MARIBYRNONG RIVER FLOOD EVENT INDEPENDENT REVIEW

Flemington Racecourse Floodwall Second Addendum 19 April 2024

10. This Report is a second Addendum to the Final Report and addresses Terms of Reference 6 and 7.

Figure 6: Calibration results for 2024 Maribyrnong River Flood Model: Modelled and recorded water levels at Chifley Drive gauge for the 2022 Flood Event.
(Source: Jacobs, 2024b).

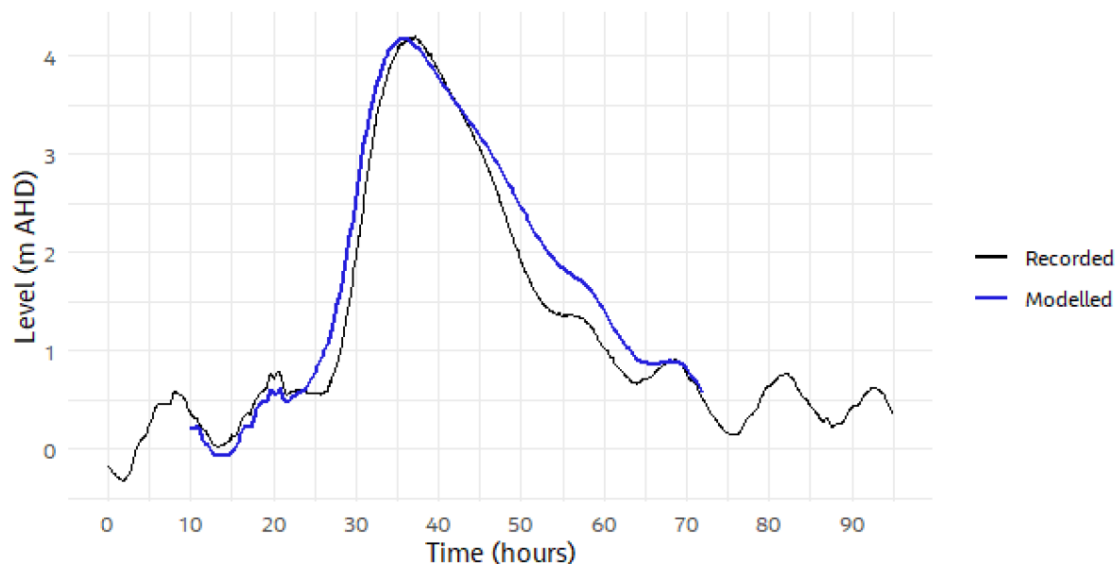
26. It can be seen from Figure 6 that the modelled flood response (blue line) matched the recorded flood response (black line) well, especially in terms of peak water level. Consequently, based on the evidence made available to the Review Panel, the 2024 Maribyrnong River Flood Model seemed to be calibrated well to the October 2022 Flood Event.

27. However, it should be noted that development of the 2024 Maribyrnong River Flood Model had not been completed at the time of writing and the Review Panel did not have access to the full calibration report.

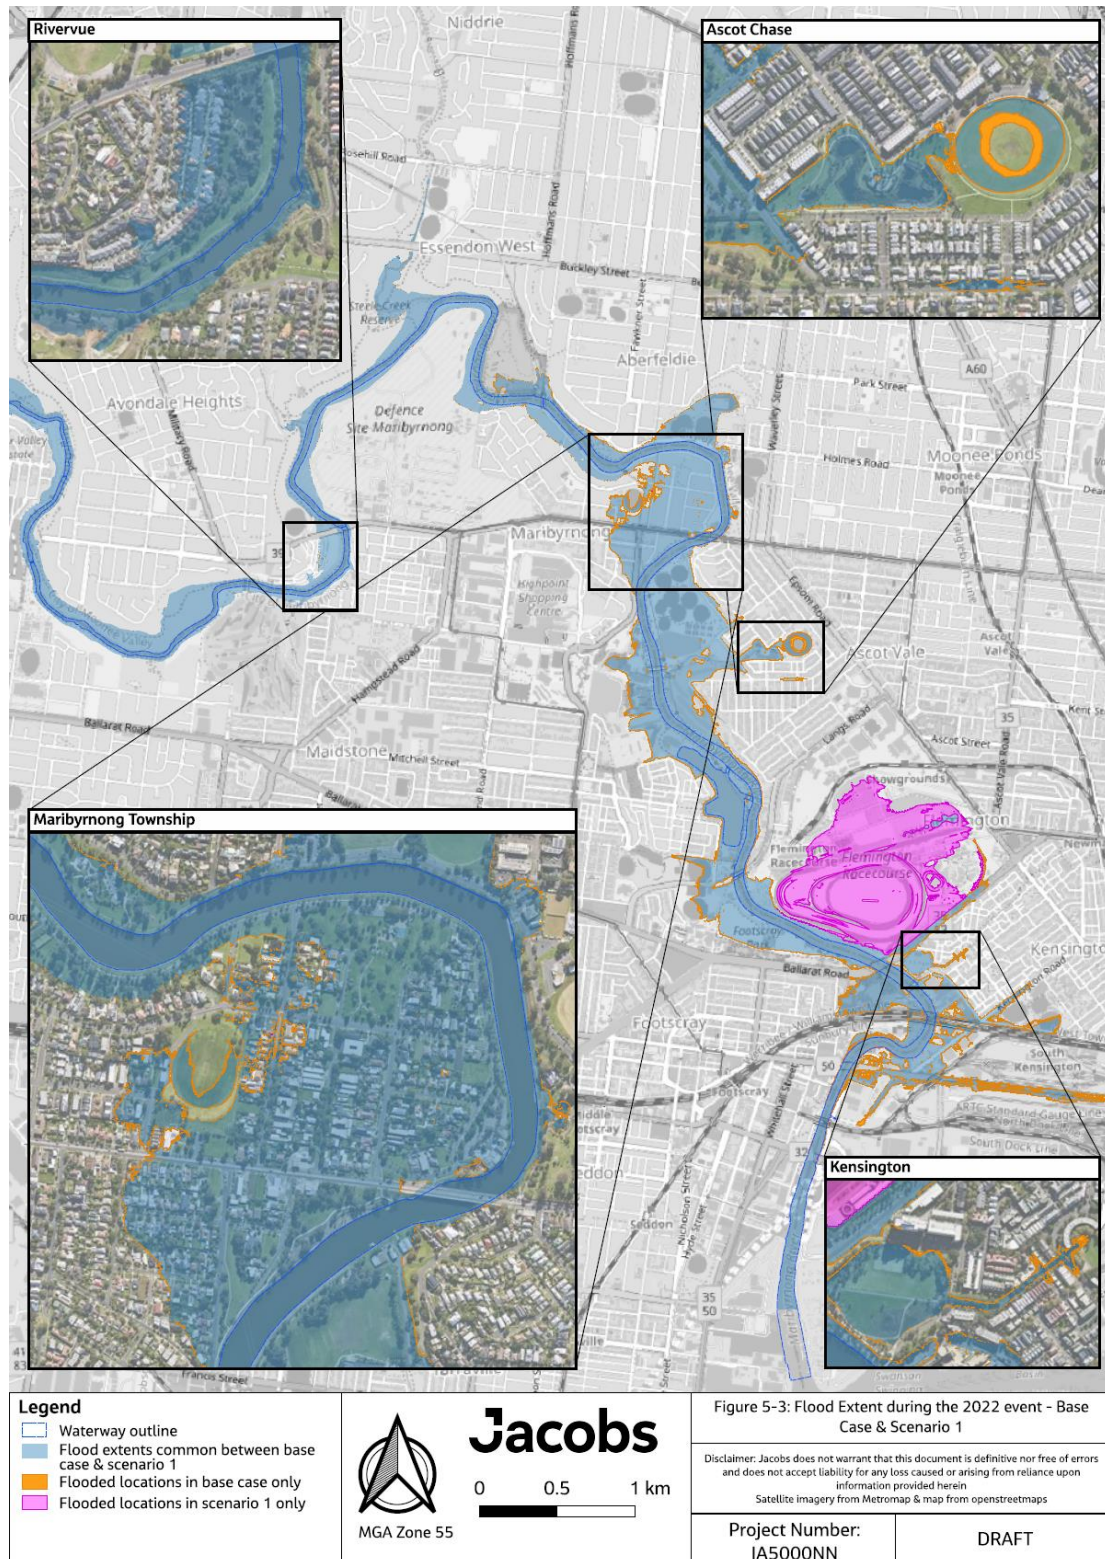
- a. Construction of the Floodwall and associated compensatory works increased the extent of the flooding in some areas (see orange areas

in Figure 7). The modelled increase in flood extent resulting from the construction of the Floodwall and associated compensatory works is approximately 1% (Jacobs, 2024b). The area where there is an increase in flood extent is distributed both upstream and downstream of the Floodwall.

- a. Protected the Flemington Racecourse from flooding (see pink areas in Figure 7 and green areas in Figure 9).
- b. Did not have a measurable impact on Rivervue retirement village.
- c. Increased the depth of flooding in some areas (see Figure 9).

Figure 8: Water level impact of the Floodwall at Raleigh Road Bridge prepared using model results provided by Jacobs
(Source: Analysis of model results provided by Jacobs by the Panel).

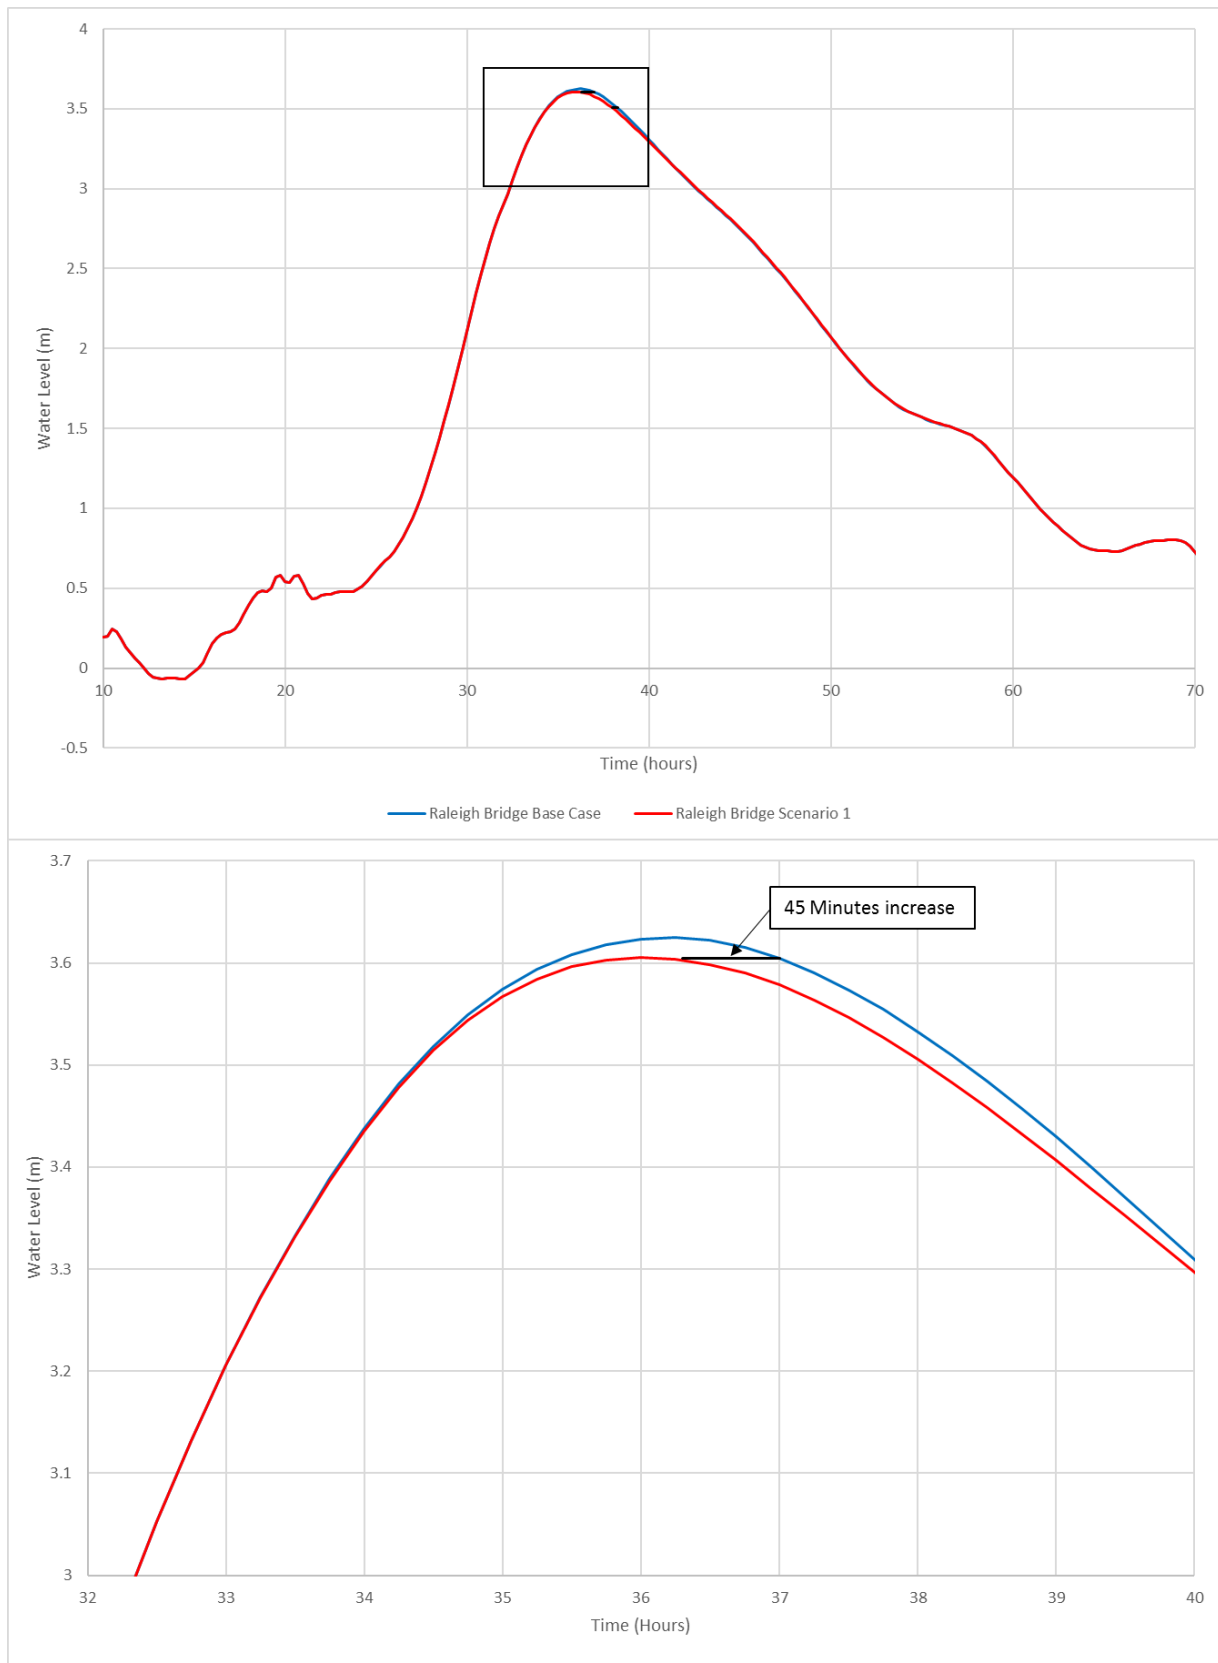
- b. Construction of the Floodwall and associated compensatory works may have contributed to the duration of inundation of some of the flooded areas. In their report, Jacobs concluded that “the duration of the flood peak did not change within the model reporting tolerance of five minutes by the presence of the VRC flood wall” (Jacobs, 2024b). Upon reviewing detailed time series outputs, the Review Panel concludes that:
 - i. The only areas where the duration of inundation may have been increased due to the construction of the Floodwall and associated compensatory works are at the fringes of the flood extent. Time series output points have not been provided in these areas.
 - ii. At Raleigh Road Bridge, the change in the rise of the flood is within the tolerances of the accuracy of the model, and the peak is extended by around 45 minutes (Figure 8).

Figure 9: Map showing the modelled increase or decrease in flood depth along the lower Maribyrnong River during the October 2022 Flood Event as a result of the construction of the Flemington Floodwall and associated mitigation works obtained using the 2024 Maribyrnong River Flood Model.

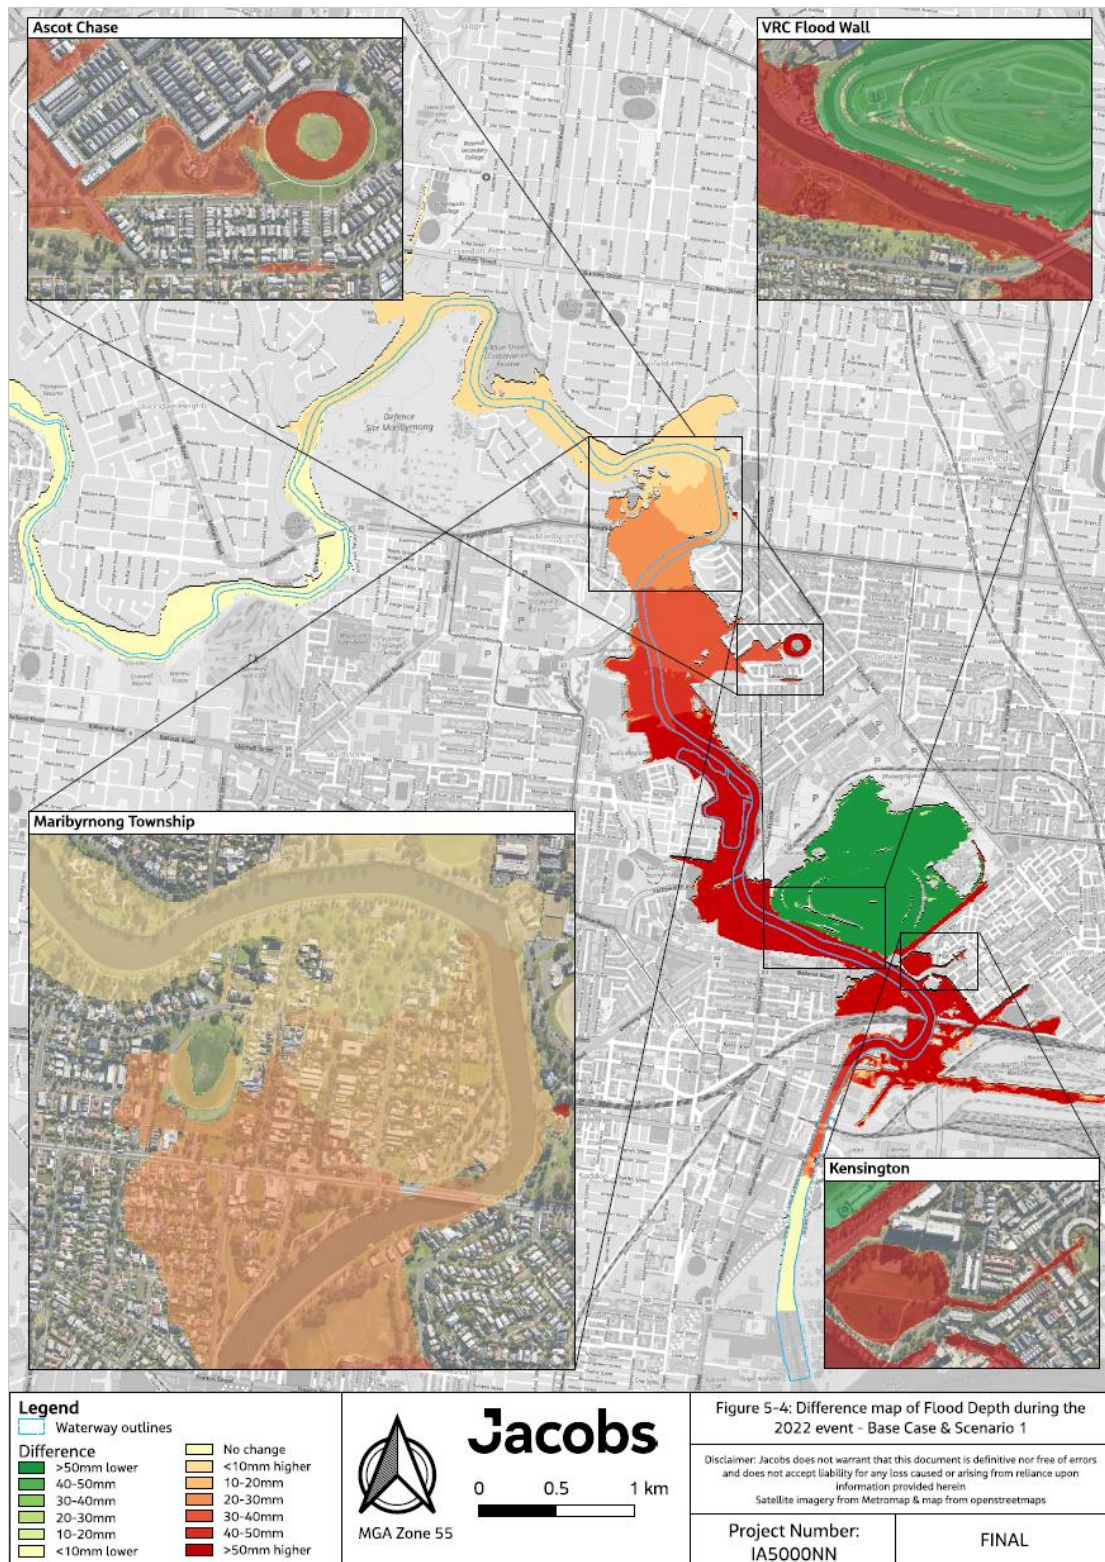
36. The modelled increase in water level resulting from the construction of the Floodwall and associated compensatory works exceeded significantly in several locations the level of +10mm, which is today considered a generally acceptable impact of developments. Those locations included:

- a. An increase of 80mm directly adjacent to the Floodwall in the Maribyrnong River channel, with this impact tapering off upstream of the Floodwall.
 - b. An increase of 8-10mm in the upstream parts, and up to 30mm in the downstream parts, of the Maribyrnong township, which affected approximately 240 residential lots in this area. Specifically:

- i. There was an increase of 8mm at the flood marker on the corner of Chifley Drive and Plantation Street; and
 - ii. There was an increase of 27mm at Essendon Canoe Club.

- c. An increase of 60-65mm in the industrial areas of West Melbourne and Kensington adjacent to the Maribyrnong River that flooded during the October 2022 event.

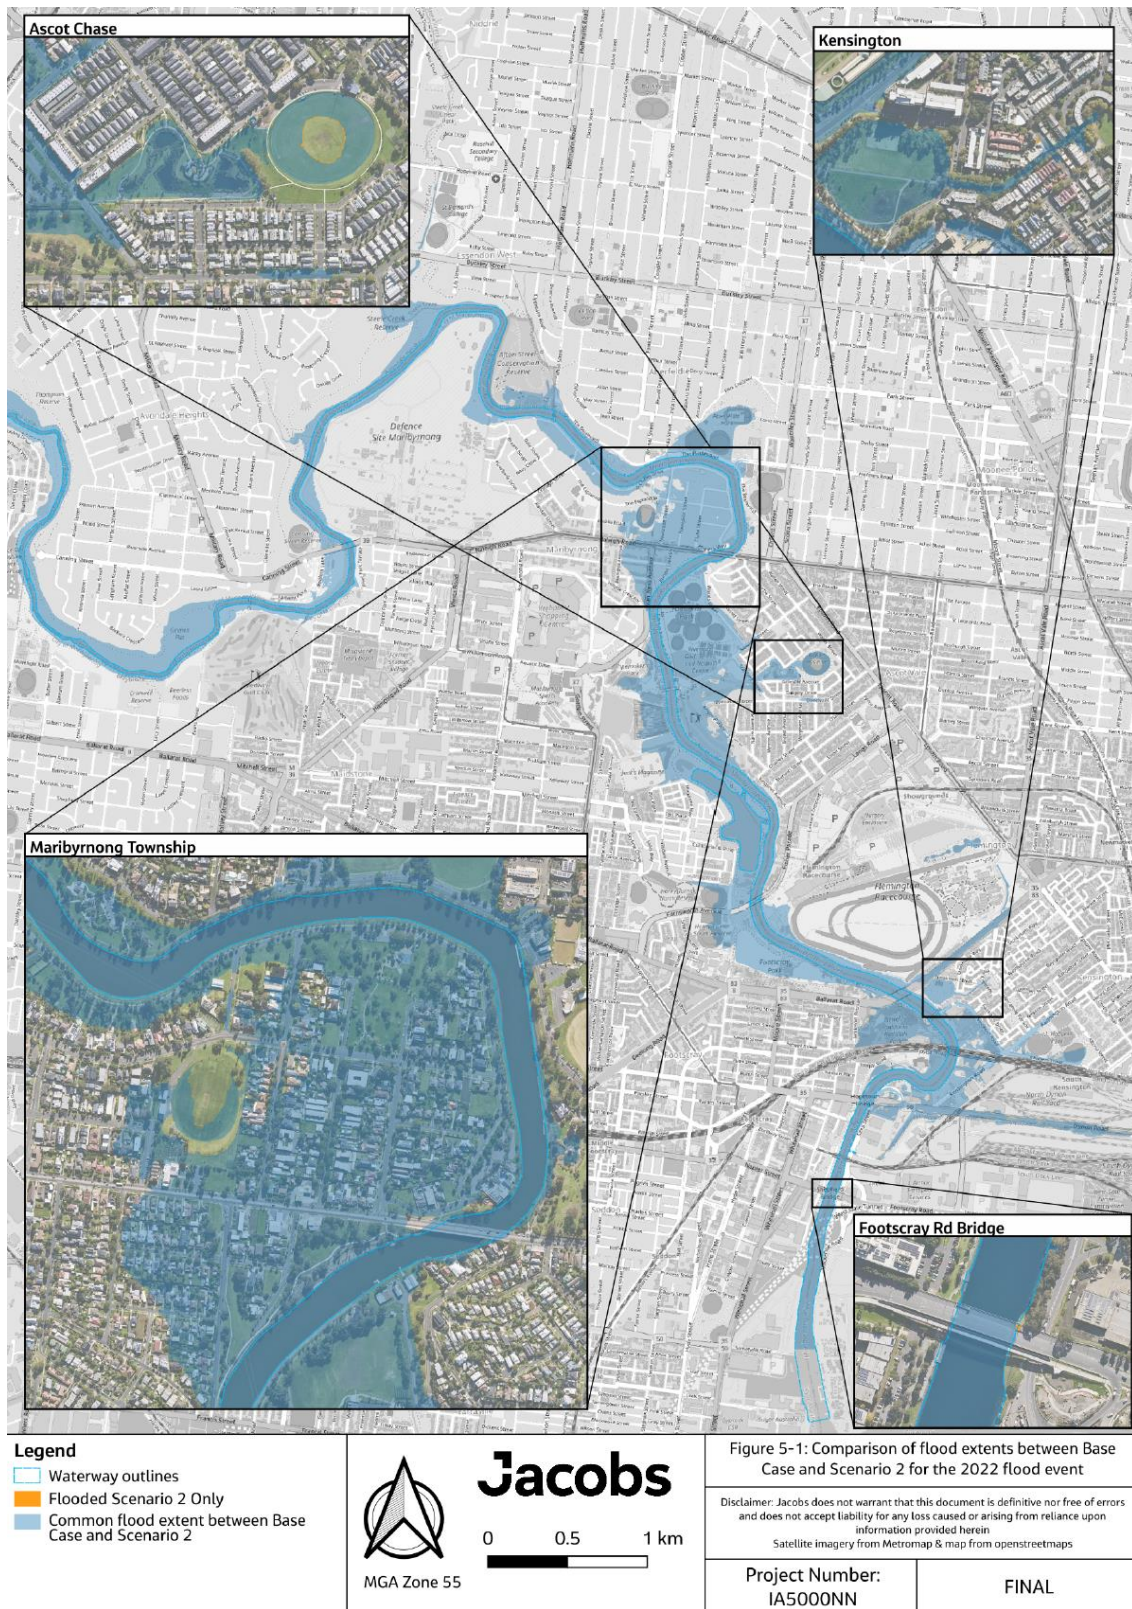
39. The information provided to the Review Panel also clearly indicates that the compensatory works were largely ineffective at mitigating the effect the Floodwall had on the October 2022 Flood Event (Figure 10). The reports provided by Jacobs concluded that “the outcome of the modelling indicates that, for the October 2022 flood event, when the mitigation works are removed, there is a relatively minor change to the peak flood levels and a negligible impact on the extent and duration of the flood peak.” (Jacobs, 2024c), with the compensatory measures mitigating depth of flooding by up to 10mm in the vicinity of Footscray bridge and 1mm in the Maribyrnong Township (Jacobs, 2024a).

40. Analysis of the raw model outputs by the Review Panel indicates that for the October 2022 Flood Event:
 - a. The compensatory works reduced the flood level by between 8mm and 10mm for approximately 500m upstream of Footscray bridge and by between 4mm and 8mm for a further 2km upstream. Beyond this, the impacts of the compensatory works were negligible.

- b. The compensatory works showed negligible mitigating impact on any flooding in residential areas.
 - c. The compensatory works reduced flood levels by 4-5mm in the industrial areas of West Melbourne and Kensington adjacent to the Maribyrnong River.

- d. The compensatory works were ineffective at mitigating the magnitude of the impact of the Floodwall.
41. Consequently, based on the modelling results of Jacobs (2024c), the Floodwall compensatory works did not “neutralise” or “overcompensate” for the impacts of the Floodwall as had been stated by GHD in 2003.
